A. Engine 601

Cylinder block/crankcase (starting 10/84)

B. Engine 602, 603

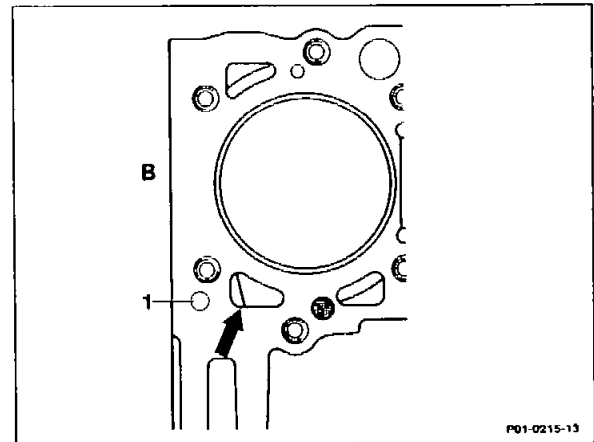
On this cylinder block the hole for the fitted sleeve (for locating the cylinder head) has been moved farther toward the rear (shaded circle) and the oil passage (1) farther toward the front.

Cylinder head:

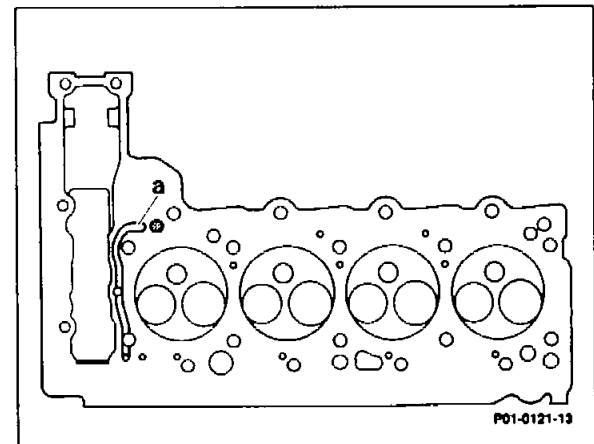
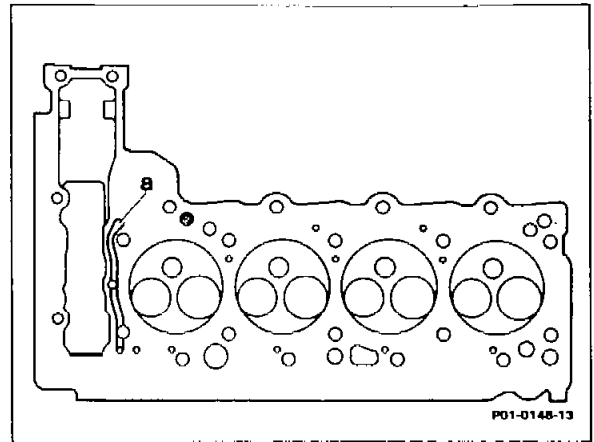
The following modifications were necessary due to the new positions of the fitted sleeves and oil passages in the cylinder block.

The fitted sleeve centering was moved farther toward the rear (shaded circle). The lateral groove (a) for lubrication of the camshaft bearings and the hydraulic elements is shorter.

Cylinder head gasket:

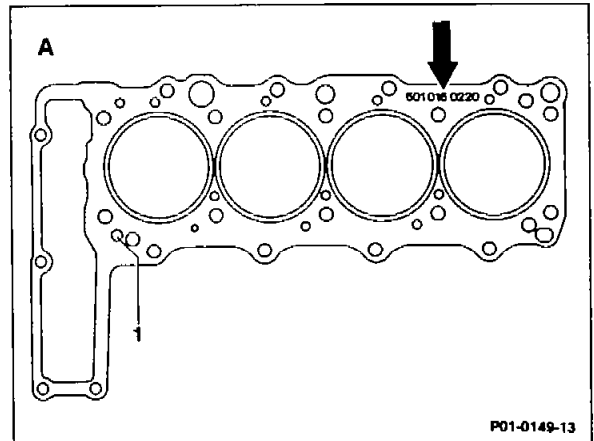
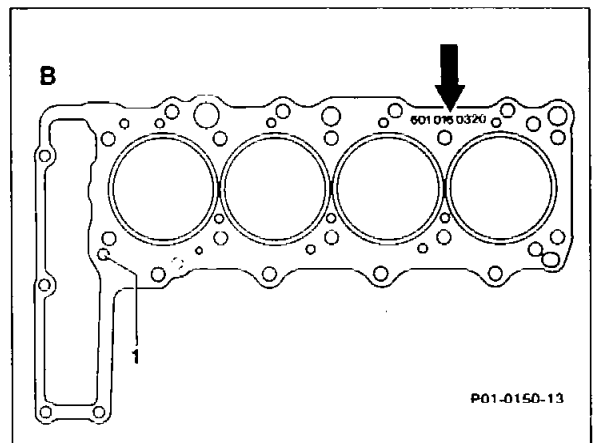
The cylinder head gasket was also modified to match the new positions of the fitted sleeves and oil passage in the cylinder block.

B 2nd version
1 Oil passage for transverse groove in cylinder head

Precombustion chamber mounting bore

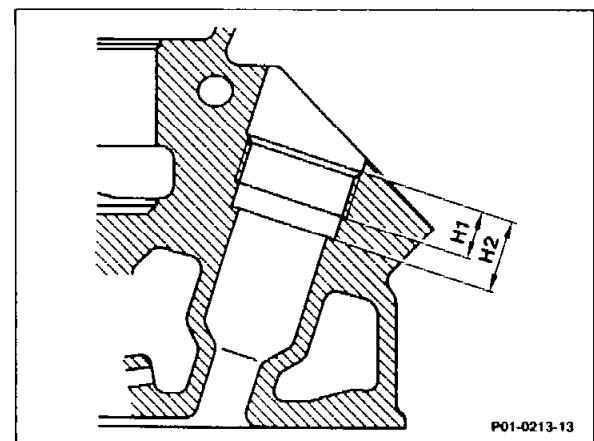
As of 04/85 the height (H1) of the thread in the precombustion chamber mounting bore was increased

2 mm for a total of 15 mm.
Dimension H2 is 22.5 mm.

Cylinder head gasket

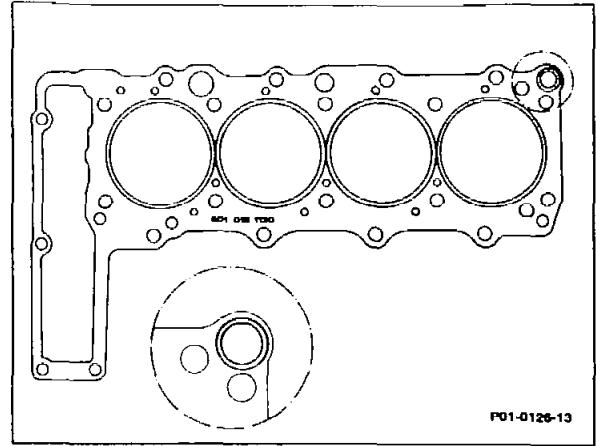
A cylinder head gasket from a different manufacturer (Ering) was installed for a short time (from 04–05/88).

On this cylinder head gasket the oil return duct (showing in circle) is equipped with a Viton seal.

Combustion chamber recess

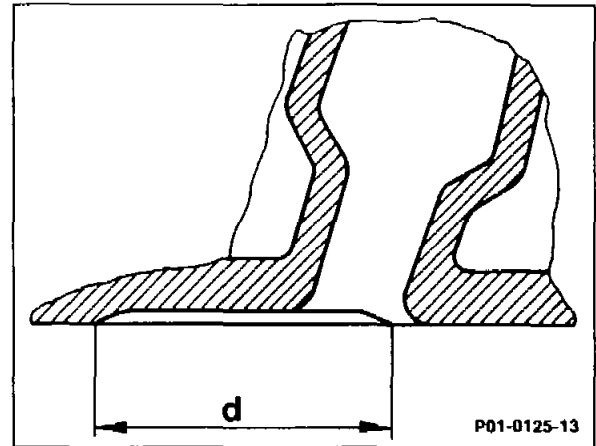
The size of the combustion chamber recess (d) was increased to reduce the thermal load in the cylinder head. Production breakpoint 06/88.

Differentiation of cylinder heads for naturally aspirated and turbo-engines

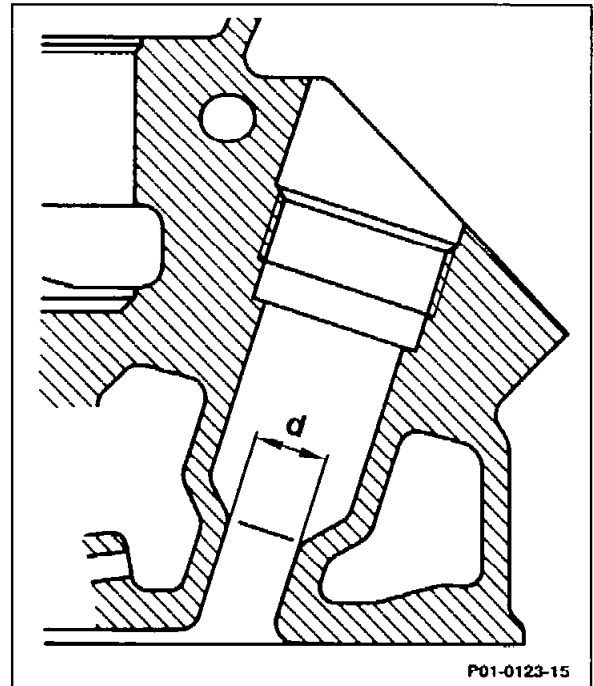
The cylinder heads for turbo-engines 602.96, 603.96 and 603.97 are reinforced at the water jacket due to the higher combustion pressures.

On turbo-engines the diameter (d) of the pre-combustion chamber bore is 15 mm, on naturally aspirated engines 14 mm.

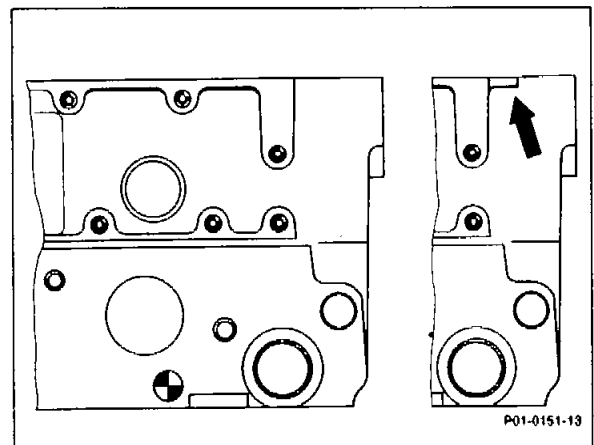
The cylinder heads on turbo-engines are provided with an identification strip. This identification strip (arrow) is located on the parting surface for the cylinder head cover at the front right.

Do not mix up cylinder heads for turbo-engines and naturally aspirated engines.

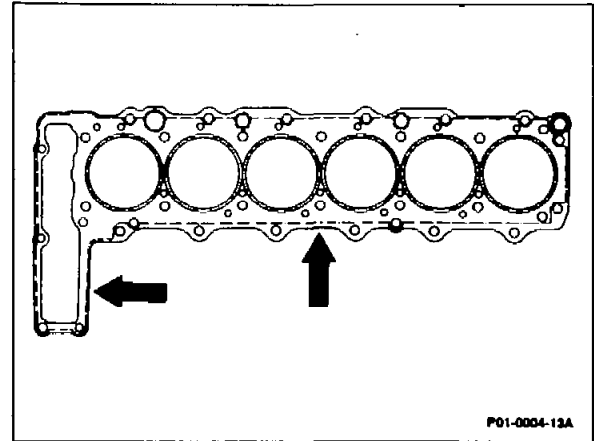
The cylinder head gasket for the turbo-engines has stainless steel inserts around the combustion chambers (arrow).

The combustion chamber inserts on the standard gaskets installed on naturally aspirated engines consist of normal sheet steel.

Only the cylinder head gaskets with stainless steel inserts are available as replacement parts for both the naturally aspirated and turbo-engines.

Cylinder head gasket with Viton sealing ring

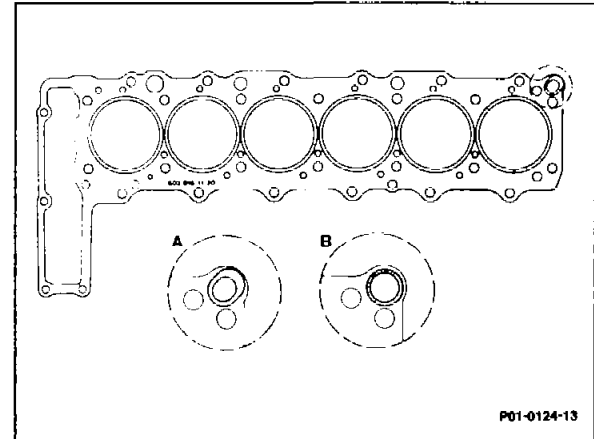
Since 03/87 a Viton sealing ring is inserted at the rear oil return passage to prevent oil leakage.

- A 1st version with sheet metal jacket
- B 2nd version with Viton sealing ring

Modifications In area of timing chain case

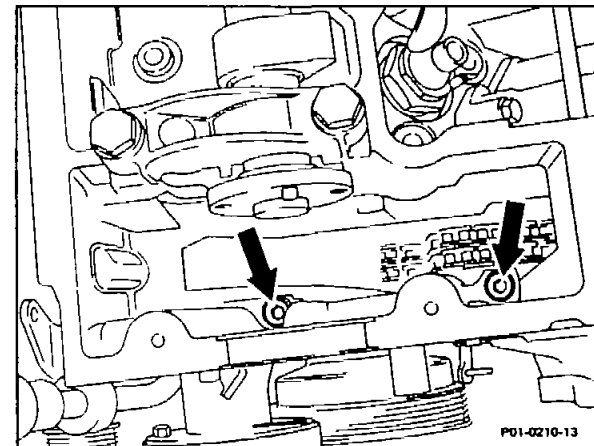
Since 09/87 on engine 602.91 and since 10/87 on engine 603.91 for production reasons the height of the bridge in the cylinder head in the area of the timing chain case was increased to 32 mm (previously 12 mm).

This modification made it necessary to change the dimensions of the two cylinder head bolts (arrow). The new bolt length is M 8 × 50 (previously M 8 × 30).

Cylinder head gasket for improved sealing

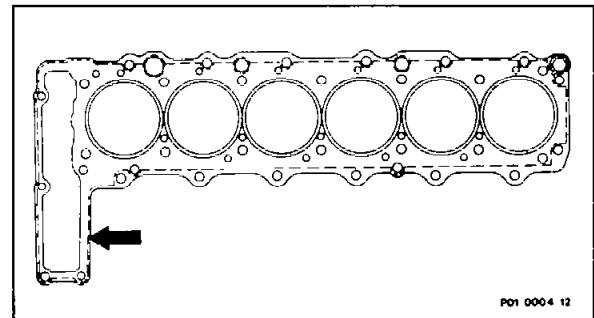
The cylinder head gasket has been equipped with circumferential silicone sealing strips (arrow) on both sides and a Viton sealing ring at the oil return passage at the rear right to better prevent water and oil leakage.

Cylinder head gasket, engines 602, 603 (except for engine 603.970)

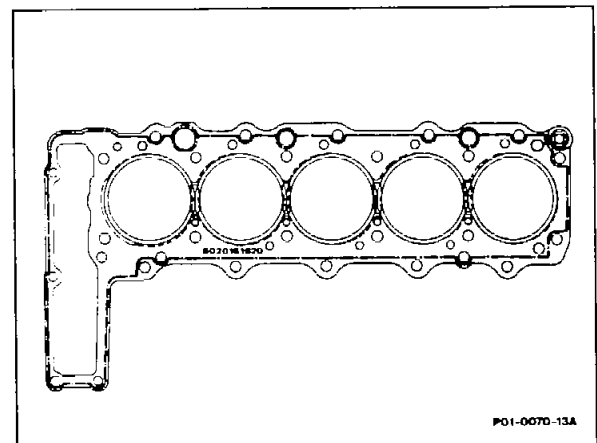
The combustion chamber insert (dotted line) has been modified at the 1st cylinder on the cylinder block side as of 01/90.

Cylinder head gasket, engine 603.970

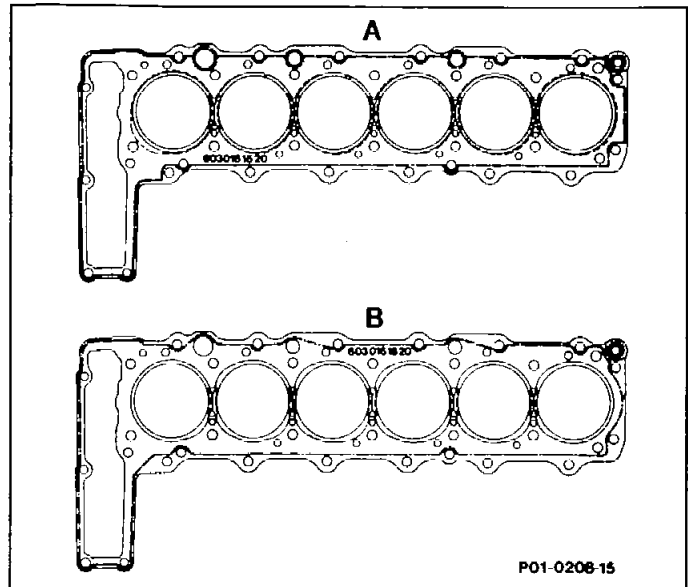
As of 01/90 combustion chamber insert modified Silicone sealing strip position changed on both sides.

- A. 1st version (Götze)
- B. 2nd version (Elring)

Cylinder head gasket engine 603.971

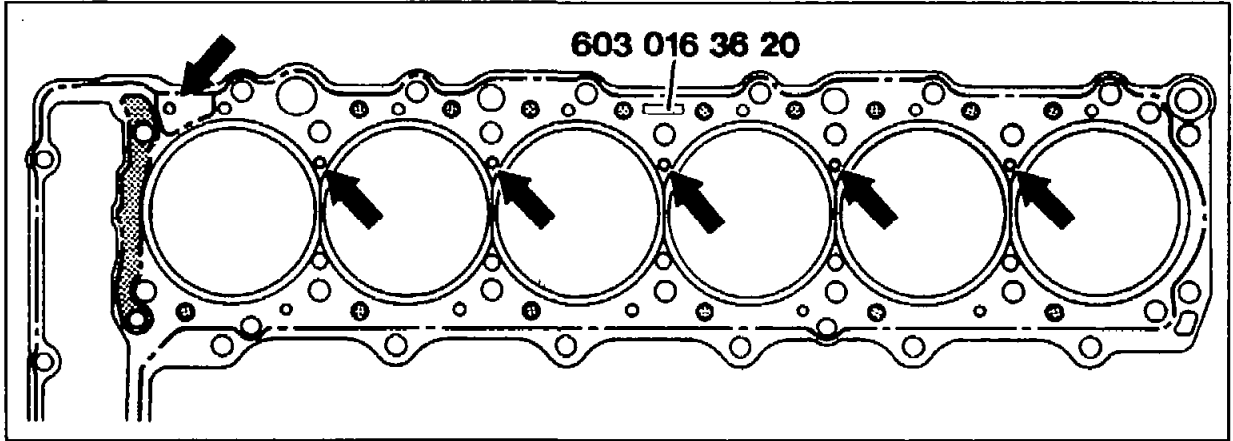
Since 11/92 with 6 holes (arrows) in the web area.

Improved gas seal at contact point to timing case cover (shaded area).
